FLIGHT DESIGN USA SAFETY DIRECTIVE No.15

Revision 1

Trim Tab Reinforcement

Fig B1 & B2: Reinforcement installed to the trim tab
(Tab shown bottom surface facing up)

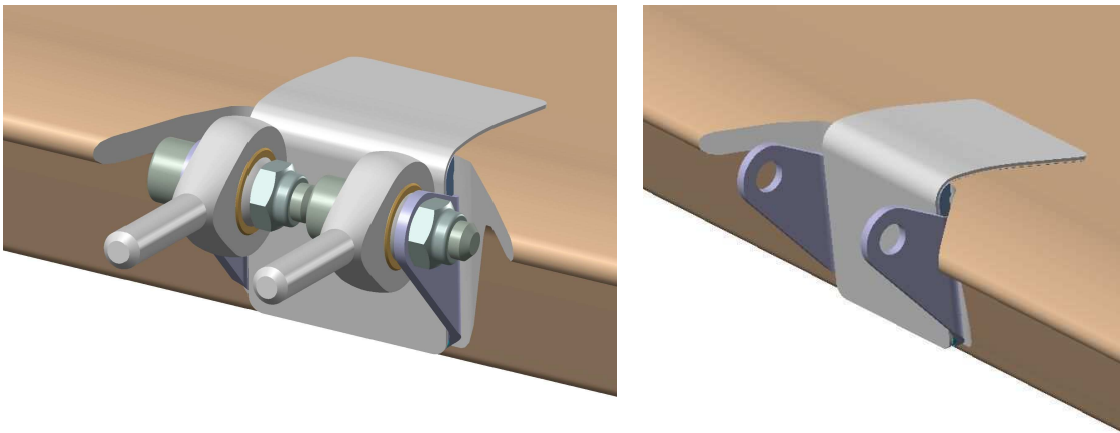
The reinforcement procedure consists of reinforcing the point at which the control horn is bonded to the trim tab by the addition of specifically designed part manufactured by Flight Design (WA 3011011). The part is glued (bonded) to the control rod bracket and the lower trim tab surface with resin and delivers a secondary load path for the trim tab control forces.

The modification can be done without removing the trim tab, and does not require painting. (Figs.B1 & B2)

The procedure shall be completed according to Flight Design document: [070625- Trim Tab Reinforcement Procedure](#) that accompanies this Safety Directive, and supplemented by the Maintenance Manual.
